**City Planning Commission Meeting – January 13, 2015**

**CONSIDERATION – SUBDIVISION DOCKET – 158/14**

**Applicant: 800 Bartholomew Street Development, LLC**

**Proposal:** Subdivision of Lots A, C, D, D-2, 8, 9, &10 into Lots 20, 21, 22, 23, 24, 25, 26, 27, 28, 29, 30, & 31.

**SQ. NO. 242**  
**THIRD DISTRICT**  
 A Resubdivision of Lots "A", "C", "D", "D-2", "E", "G" & "I" into Lots  
 20, 21, 22, 23, 24, 25, 26, 27, 28, 29, 30, & 31

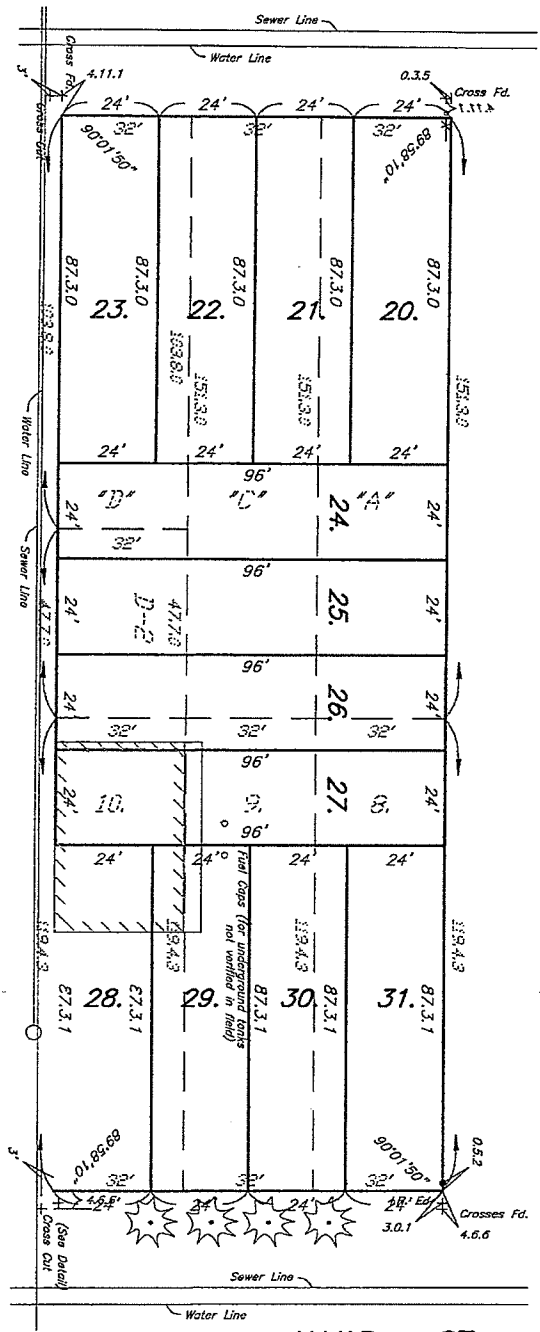
The Department of Safety and Permits wants the survey to indicate demolition of an existing vacant building. The survey was recently revised and at the time of this report, the City Planning Commission has not received written responses from the Department of Public Works, the Historic District Landmarks Commission, the Department of Property Management Division of Real Estate and Records, and Entergy regarding

Residential Uses in the LI Light Industrial District must comply with the requirements for the RM-2 Multiple-Family Residential District according to **Article 7, Section 7.3.7** Height, Area, and Bulk Requirements of the Comprehensive Zoning Ordinance. The applicant proposes to construct single-family residences on the proposed lots. According to **Article 4, Section 4.9.7 Table 4.I** of the Comprehensive Zoning Ordinance, each lot must have a minimum width of thirty feet (30’), minimum depth of ninety feet (90’), and minimum lot area of 3,125 square feet. Each proposed lot is substandard in lot width and lot area. Proposed lots 21, 21, 22, 23, 28, 29, 30, and 31 are also substandard in lot depth.

The proposed lots are smaller in width, depth, and area than most parcels on the square. However, the proposed lots have frontages on the three adjacent streets so their size will not have the visual impact of row houses. The proposed lot dimensions are within the range of width and depth variations in the surrounding neighborhood. The required waivers have been addressed in Zoning Docket 5-15.

The proposed lots will have frontage on Bartholomew, Burgundy, and Alvar Streets. The proposal will reduce the Bartholomew and Alvar Street frontages of the existing lots from thirty-two feet (32') to twenty-four feet (24'). The remaining parcels on the square that face Bartholomew Street are thirty-one feet (31') in width. The parcels across Bartholomew Street from the subject site have lot widths between twenty-five feet six inches (25'6") and thirty-one feet (31'). The average lot frontage of the parcels on both sides of Bartholomew Street is 29'5"<sup>2</sup>. The proposal does not meet the average lot frontage for Bartholomew Street. However, the proposal has received conceptual approval from the Historic District Landmarks Commission. The Commission reviewed the proposed structures for the four lots on Bartholomew Street. Their review considered siting of the structures and compatibility with the historic character of the neighborhood. The proposal will divide three thirty-two foot (32') wide lots facing Bartholomew Street into four lots. The smaller frontage of the proposed lots will not adversely affect the development pattern of the area given that the property has been used as surface parking for many years.

The proposal will create a reversal of lot frontage for the lots on Burgundy Street resulting in the required side yards of proposed Lots 24 and 27 abutting the required rear yards of proposed Lots 20, 21, 22, 23, 28, 29, 30, and 31. The reversal of lot frontage is

The original request included numeric lot names for the proposed lots. The applicant submitted a revised survey with numbered lots in time for this report. Landscaping requirements will be addressed in the corresponding conditional use request for Zoning Docket 5-15. The Department of Public Works will review the site plan as part of their review of the subdivision request. The proposal does not include any driveways for the new homes.

- The applicant shall be granted a waiver of **Article 5, Section 5.1.6 Substandard Lots** of the Subdivision Regulations to permit lot widths and lot frontages of twenty-four feet (24') for proposed Lots 20, 21, 22, 23, 24, 25, 26, 27, 28, 29, 30, and 31.

- The applicant shall be granted a waiver of **Article 5, Section 5.1.8** *Reversal of Lot Frontage* of the *Subdivision Regulations*, to permit a reversal of lot frontage for proposed Lots 24, 25, 26, and 27 which will face Burgundy Street.
